CITY OF ALBUQUERQUE

Planning Department
Alan Varela, Director

April 13, 2023

Re: Sawmill Tract J
800 20TH St. NW
Traffic Circulation Layout
 Engineer's Stamp 02-28-23 (J13-D076B)

RONALD R. BOHANNAN P.E. #7868	ENGINEER'S SEAL	800 20TH ST ALBUQUERQUE, NM	DRAWN BY SB
		CONCEPTUAL TRAFFIC CIRCULATION LAYOUT	DATE 03-15-23
			DRAWING
			SHEET # DET-1
		TIERRA WEST, LLC 5571 MIDWAY PARK PL NE ALBUQUERQUE, NEW MEXICO 87109 (505) 858-3100 www.tierrawestllc.com	JOB # 2022136

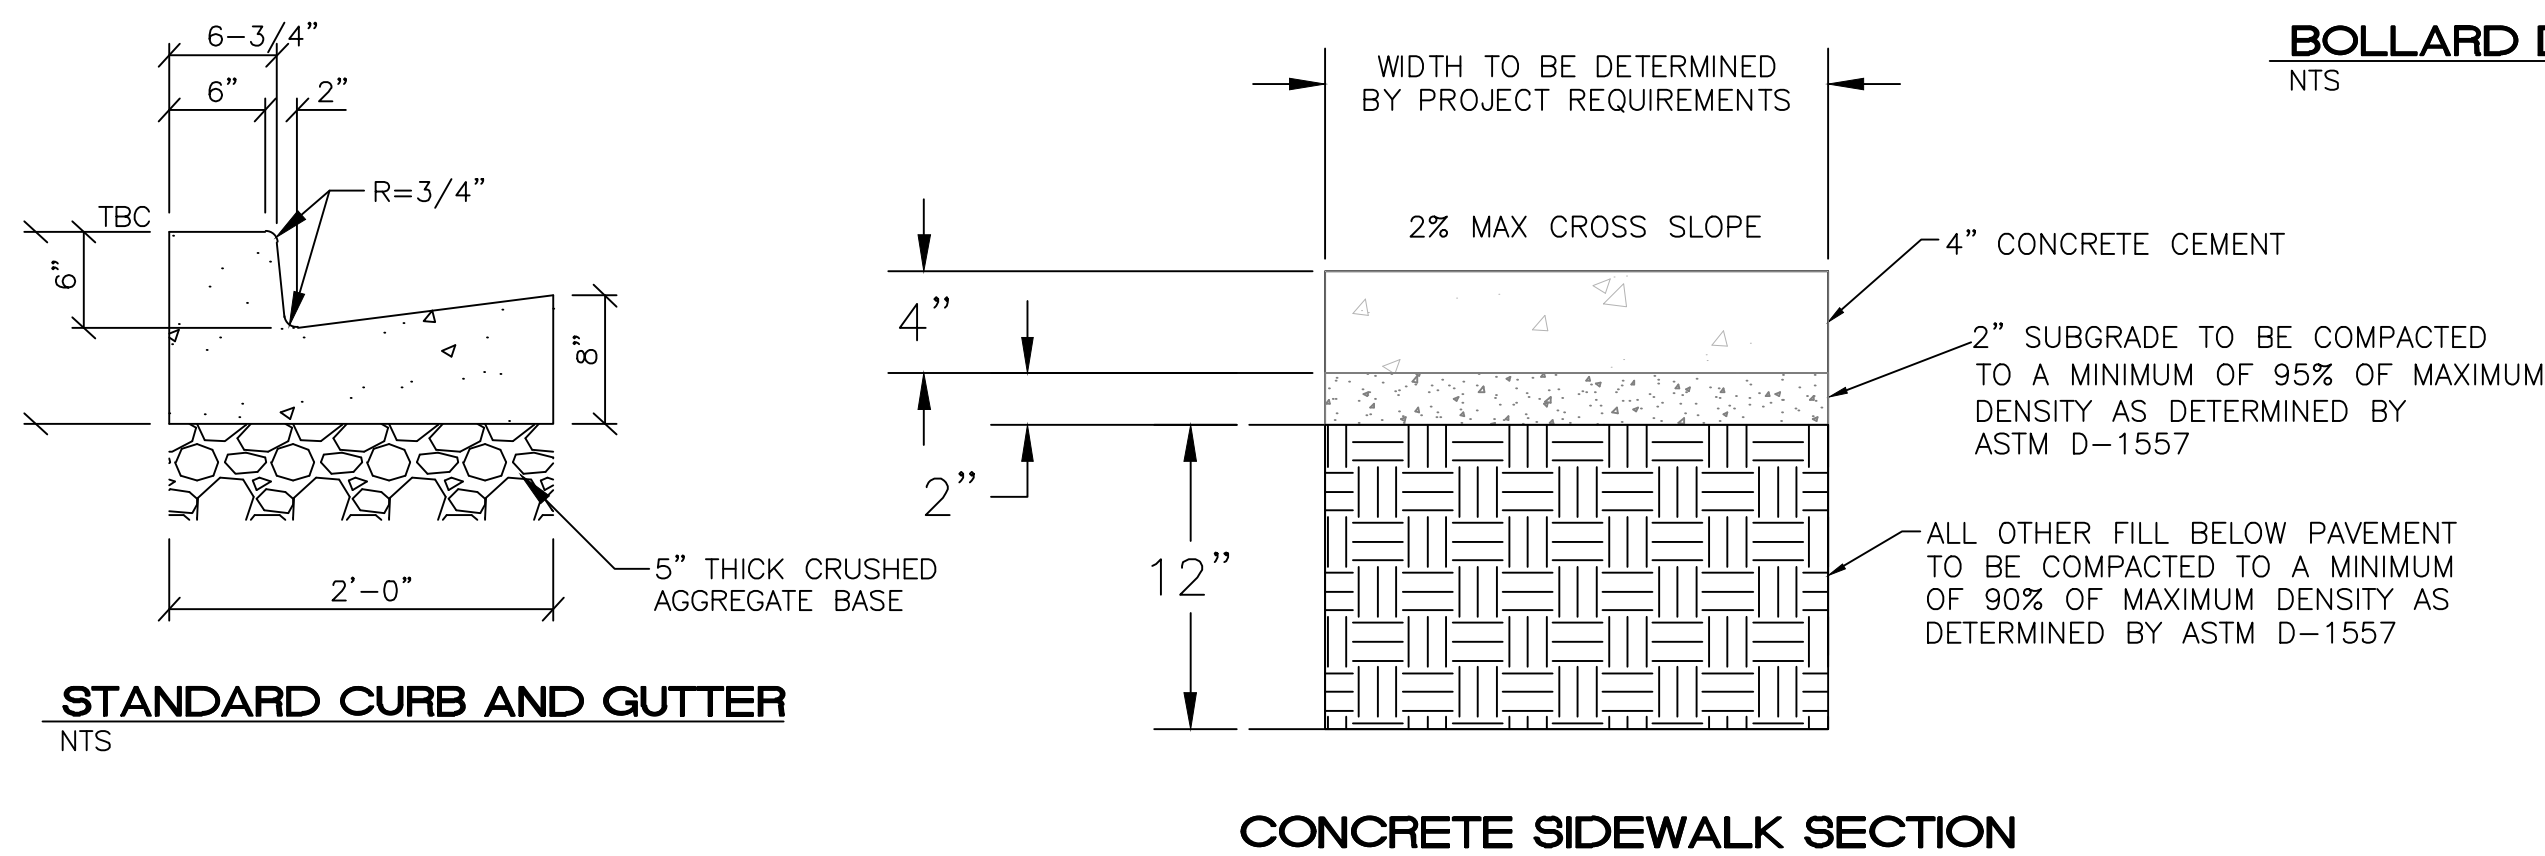
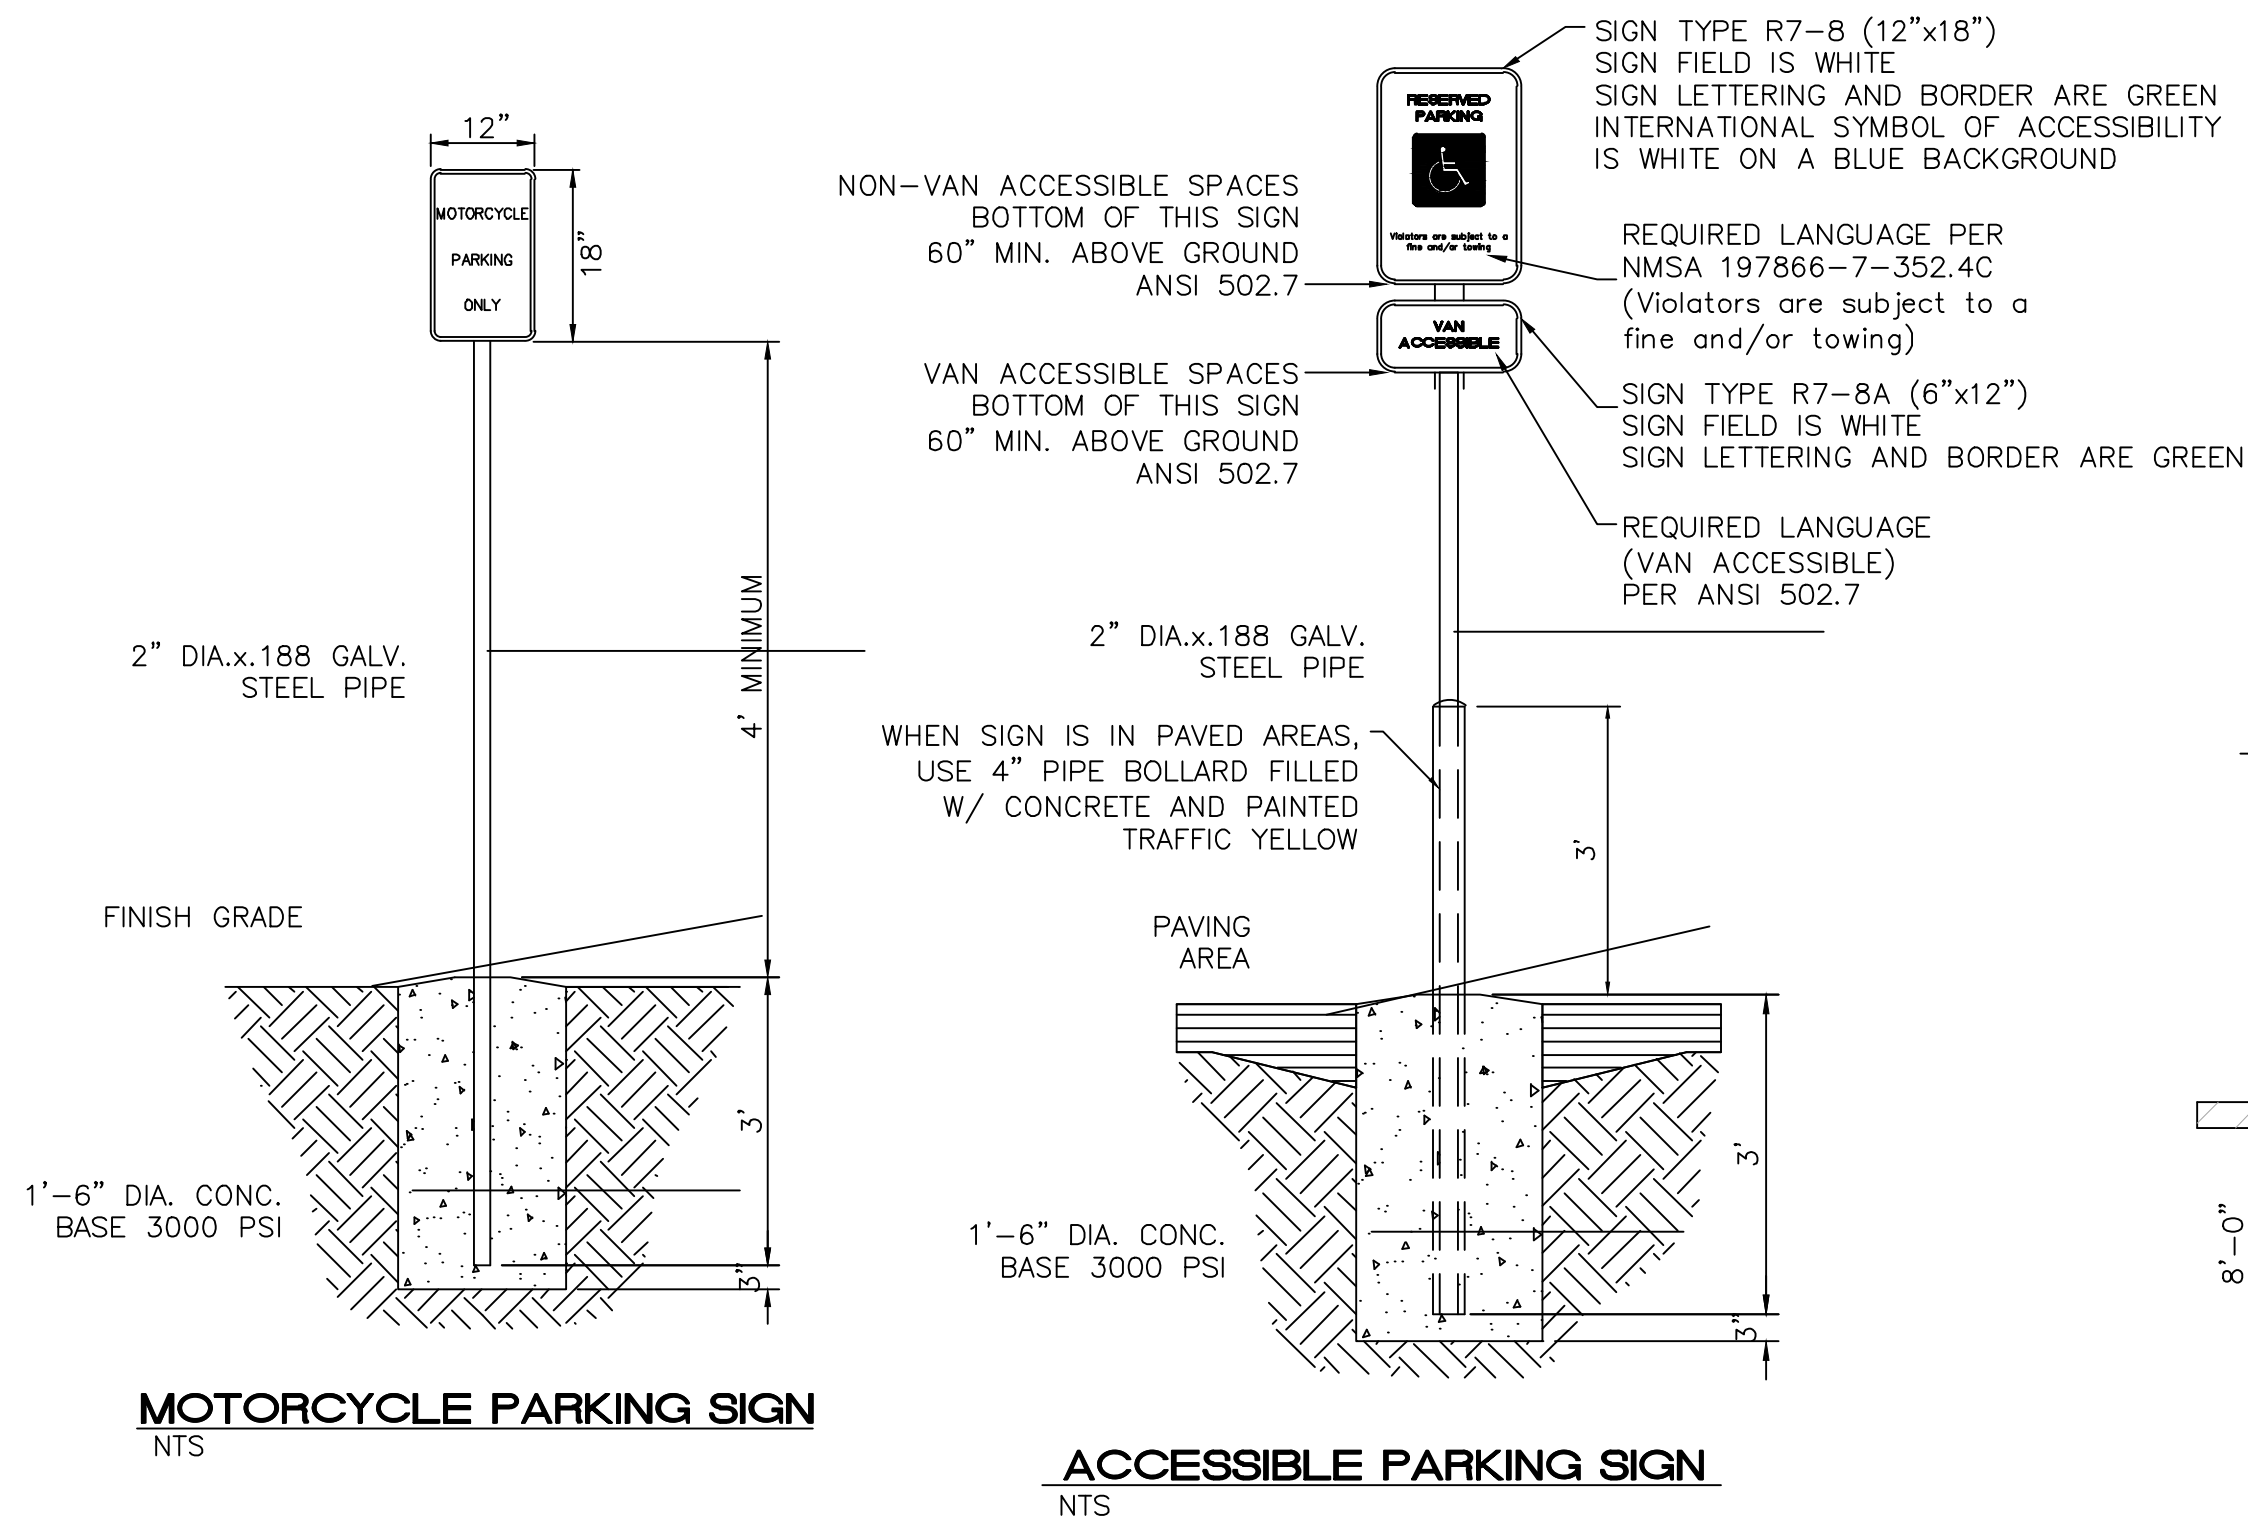
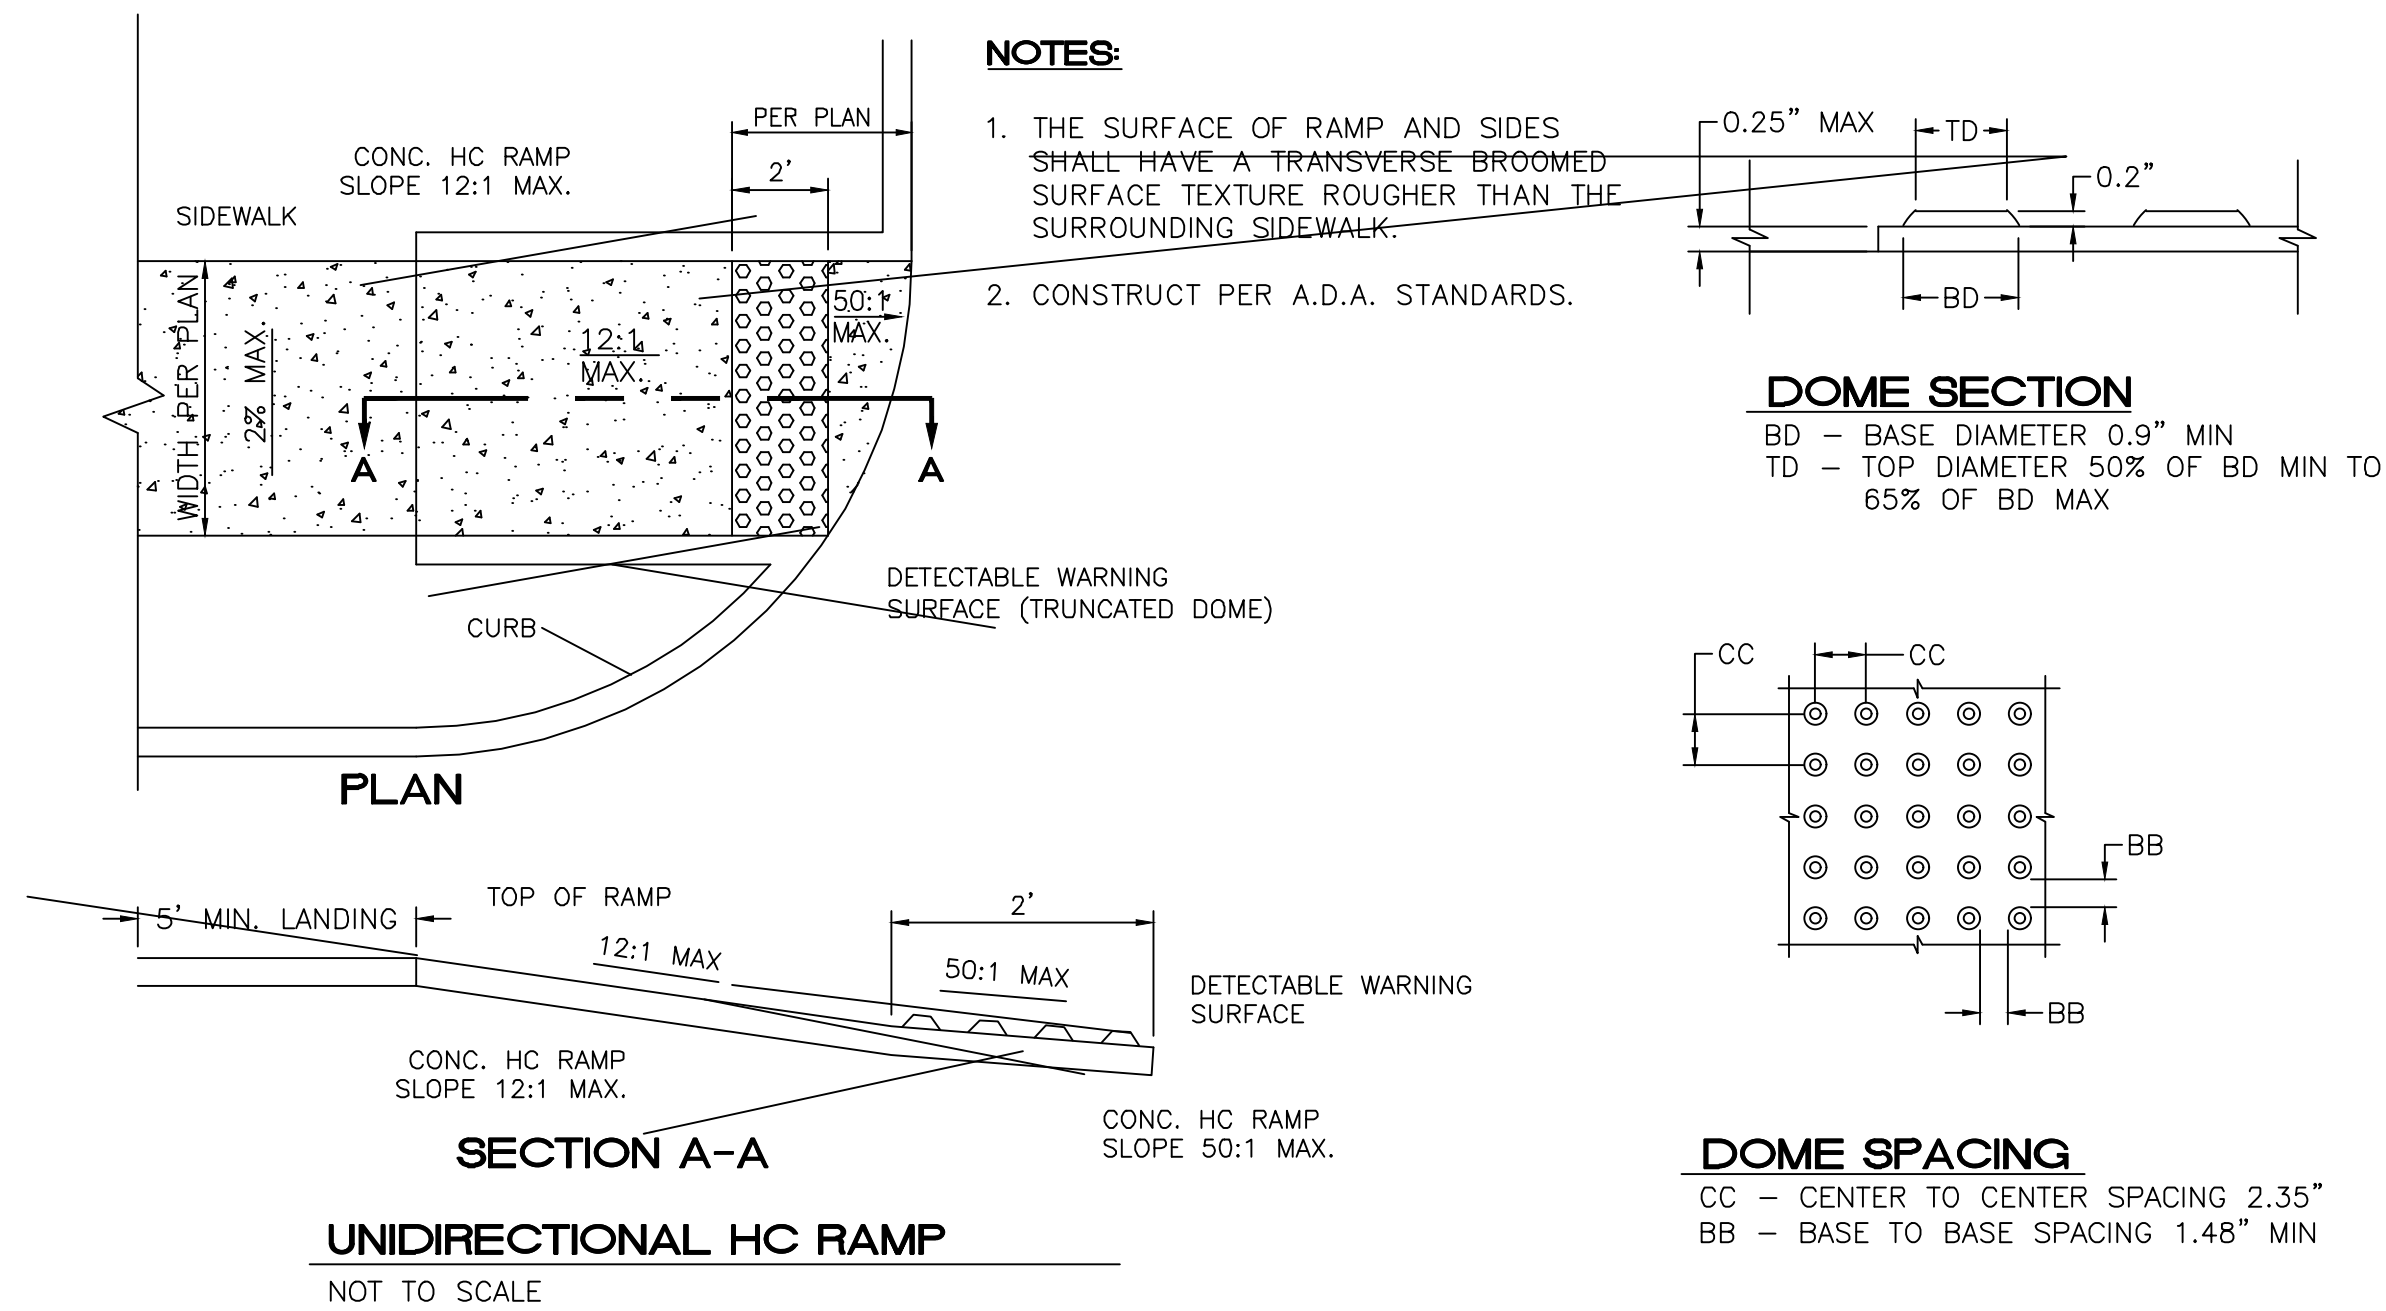
1. Identify all existing access easements and rights of way width dimensions.
2. Is there any basement or second floor parking spaces? If so, please provide a site plan showing all the proposed parking spaces, details and dimensions.
3. The site access's east leg appears to encroach with the adjacent property. Please provide the adjoining property owner agreement.

5. Please provide all proposed drive aisles width.

6. Please provide ADA aisle for all the proposed ADA parking spaces.

7. The ADA accessible spaces must include an access aisle. Van accessible aisles should be 8ft wide; all others should be 5ft wide.
8. The ADA access aisles shall have the words **"NO PARKING"** in capital letters, each of which shall be at least one foot high and at least two inches wide, placed at the rear of the parking space so as to be close to where an adjacent vehicle's rear tire would be placed. (66-1-4.1. B NMSA 1978)
9. ADA curb ramps must be updated to current standards and have truncated domes installed.
10. Please show on the site plan the location the proposed Motorcycle parking spaces.
11. The pavement marking "MC" should be shown in the opposite direction for motorcycles entering the parking space.
12. A 5 ft. keyway is required for dead-end parking aisles. Please show this dimension on

the site plan.

13. Per the IDO, a 6 ft. wide ADA accessible pedestrian pathway is required from the public sidewalk to the building entrances. Please clearly show this pathway and provide details.

14. Per DPM, a 6 ft. wide ADA accessible pedestrian pathway is required from **EACH** ADA parking stall access aisles to the building entrances. Please clearly show this pathway and provide details.

15. Define ADA pathway by labeling ramps or flush pavement.
16. ADA accessible pedestrian pathway should not be placed behind parking space or adjacent to a vehicular way. Vehicle and pedestrian/wheel chair conflicts should be avoided as much as possible.

17. Curbing should be installed to delineate landscape, parking, and pedestrian ways and identify points of access. Please call out detail and location of barrier curb.

18. Refuse vehicle maneuvering shall be contained on-site. The refuse vehicle shall not back into the public right of way.; provide a copy of refuse approval.

20. It is not apparent what type of pavement surface is being proposed. A hard driving surface will be required as part of this proposed project for parking area and drive aisles.

21. Please specify the City Standard Drawing Number when applicable.
22. Add a note stating "All broken or cracked sidewalk must be replaced with sidewalk and curb & gutter." A build note must be provided referring to the appropriate City Standard drawing.
